**ADDENDUM NO. 1
TO CONTRACT DOCUMENTS FOR THE
COYOTE WAREHOUSE PROJECT
Project No. 91234002**

Contract No. C0635

Notice is hereby given to Prospective Bidders that the Contract Documents are modified as hereinafter set forth.

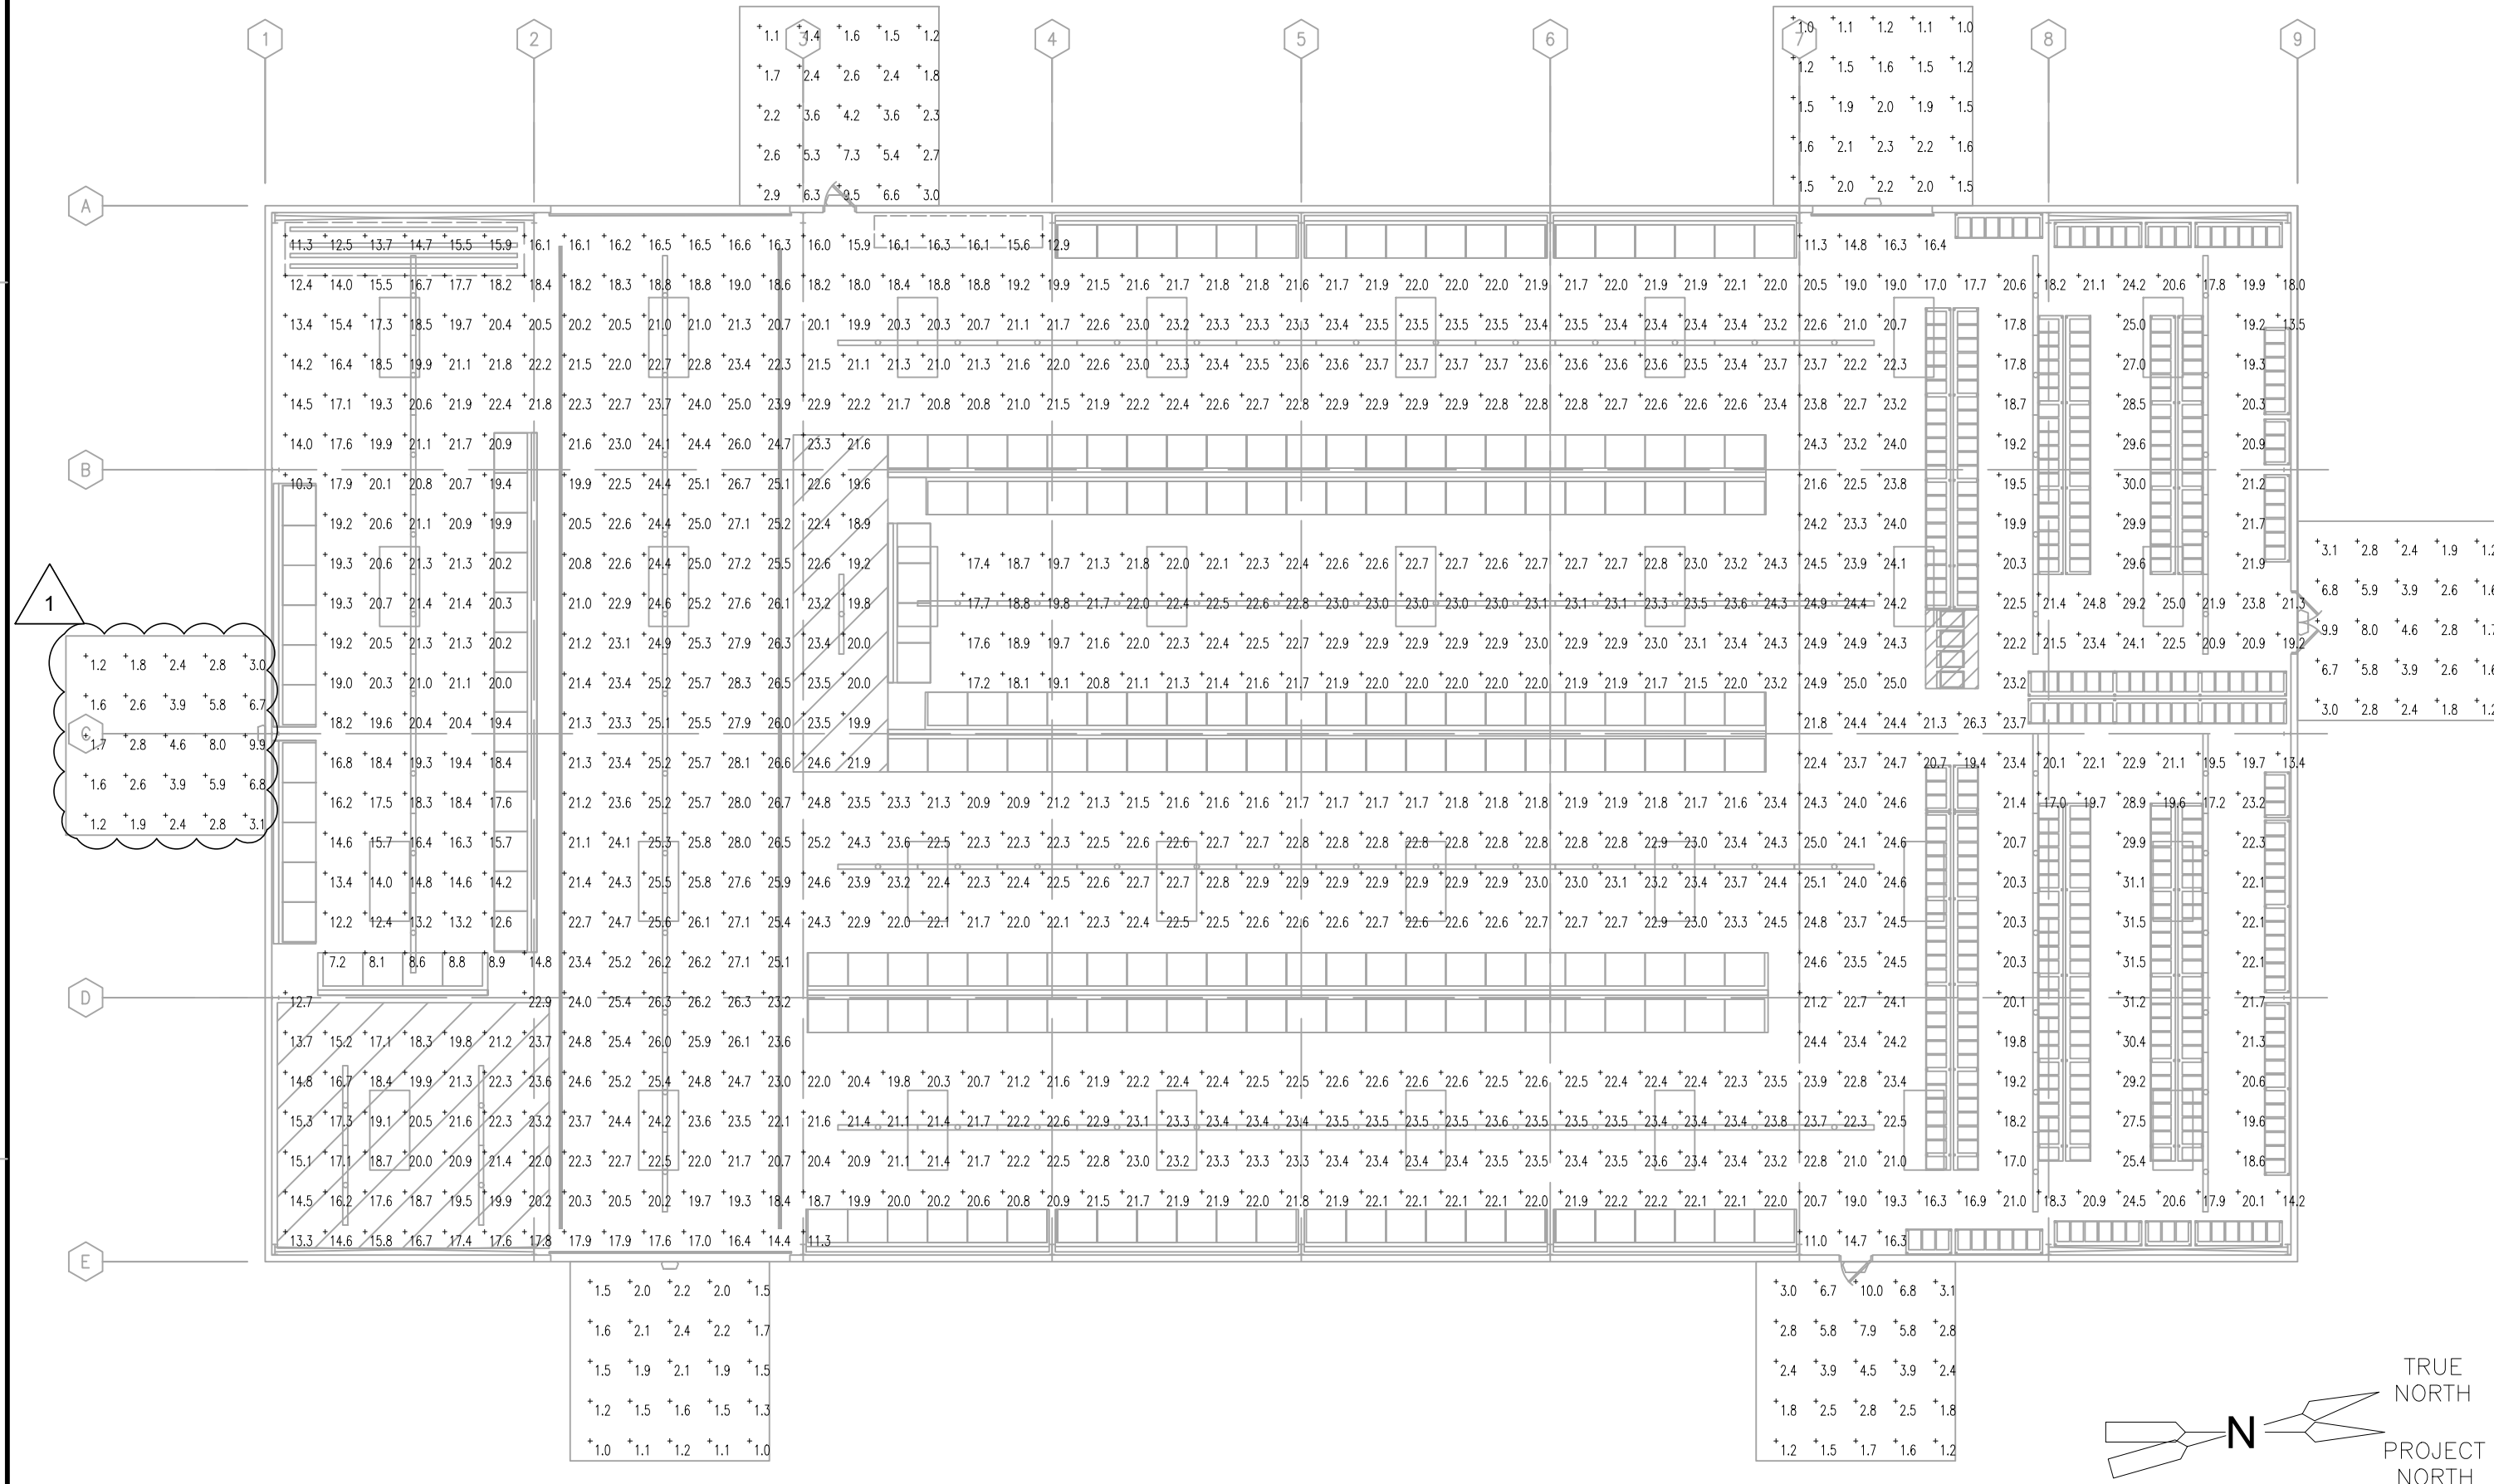
Item no.	Drawing No.	Description
D1-26	SC-01	<u>ADD</u> New Drawing SC-01 ADDITIONAL PAVING SITE LAYOUT AND PLAN. See Attachment E.
D1-27	SC-02	<u>ADD</u> New Drawing SC-02 ADDITIONAL PAVING DETAILS AND SECTION. See Attachment E.
